Traffic
UPDATE

RE: Ritz Carlton Traffic Impact Analysis Resubmittal Summary

RE: Lee Engineering Review of the Ritz Carlton Resort Traffic Impact Analysis (TIA) by CivTech dated August, 2015 – 2nd submittal

**Ritz Carlton
2nd Submittal**

Figure 29: Future Lane Configurations and Traffic Controls A

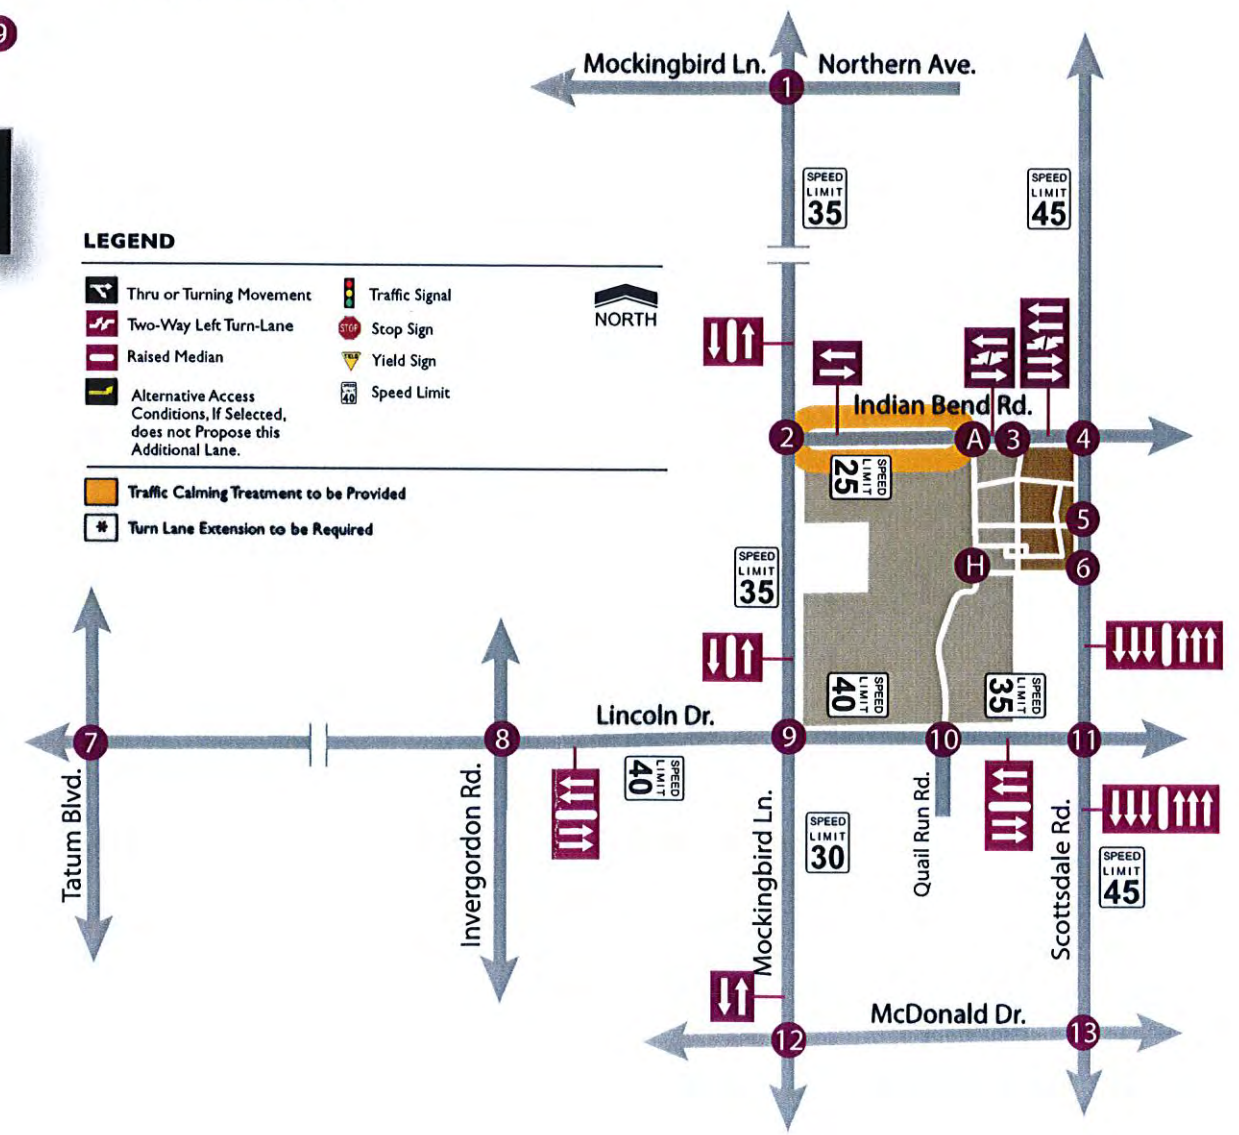
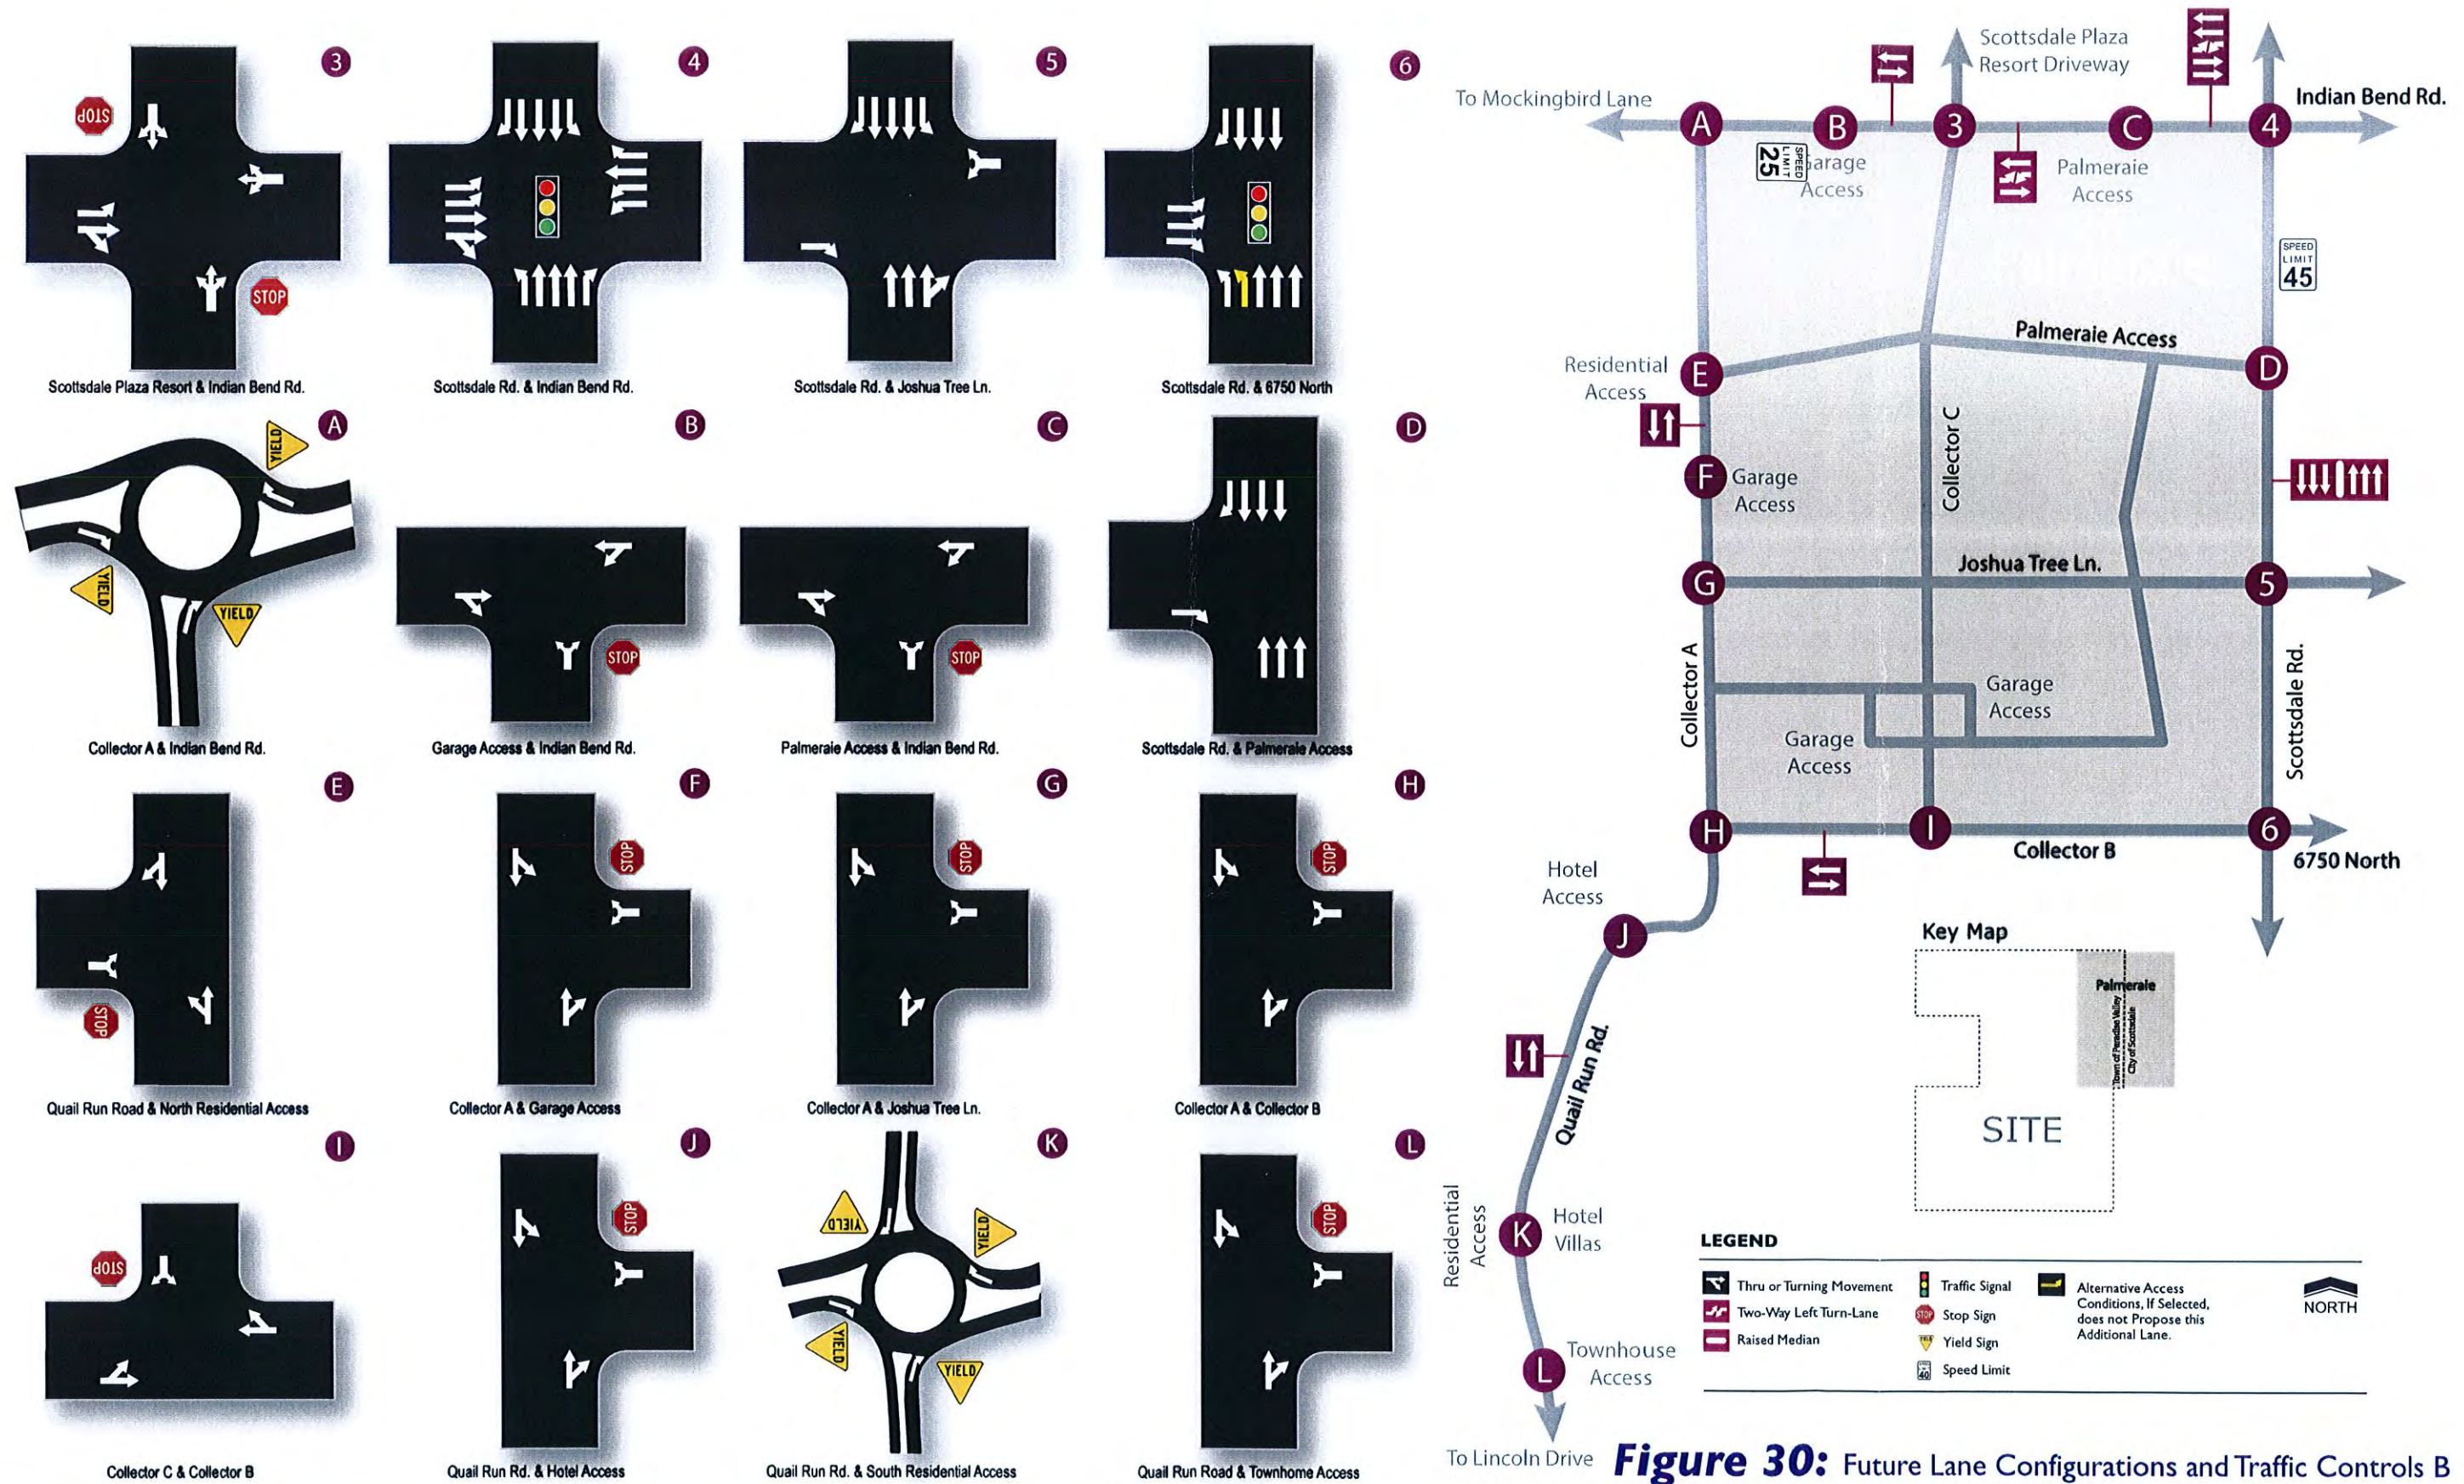
7. Any half-street improvements to the eastbound Indian Bend Road approach to Scottsdale Road should include the mitigation identified in the report (Figure 29) as well as considering any secondary improvement for increasing the northbound left-turn storage or capacity, if required, based on additional analysis at the Scottsdale Road/6750 North intersection.

7.	Paul Guzak- Lee Engineering	Figure 29 (p. 58)	1	Any half-street improvements to the eastbound Indian Bend Road approach to Scottsdale Road should include the mitigation identified in the report (Figure 29) as well as considering any secondary improvement for increasing the northbound left-turn storage or capacity, if required, based on additional analysis at the Scottsdale Road/6750 North intersection.	This intersection will be reviewed again by the City of Scottsdale with the Palmeraie TIMA and mitigation will need to be determined by both the Town of Paradise Valley and the City of Scottsdale. A statement has been added to the TIA. Agree: The eastbound approach should provide dual left-turn lanes, one (1) through lane and a shared through/right-turn lane. A second westbound through lane may be required if dual northbound turn lanes are required by the City of Scottsdale. Mitigation improvements at the intersection of Indian Bend/Scottsdale Road should meet City of Scottsdale design standards which will be determined during the review of the Palmeraie TIA.

6. Please submit a conceptual layout for Indian Bend Road improvements adjacent to the site with a transition to the Paradise Valley cross section west of the site. The intersection configuration shows two eastbound through lanes approaching Scottsdale Road but does not show two westbound lanes. Dual northbound left-turns may be needed at the Scottsdale Road and Indian Bend Road intersection; therefore, two westbound receiving lanes along Indian Bend Road should be provided.

7.	John Bartlett & Phillip Kercher			A Southbound right-turn lane should be provided at the intersection of Scottsdale Road and Indian Bend Road.	The report text and Figure 29 have been updated to include SB the right-turn lane.
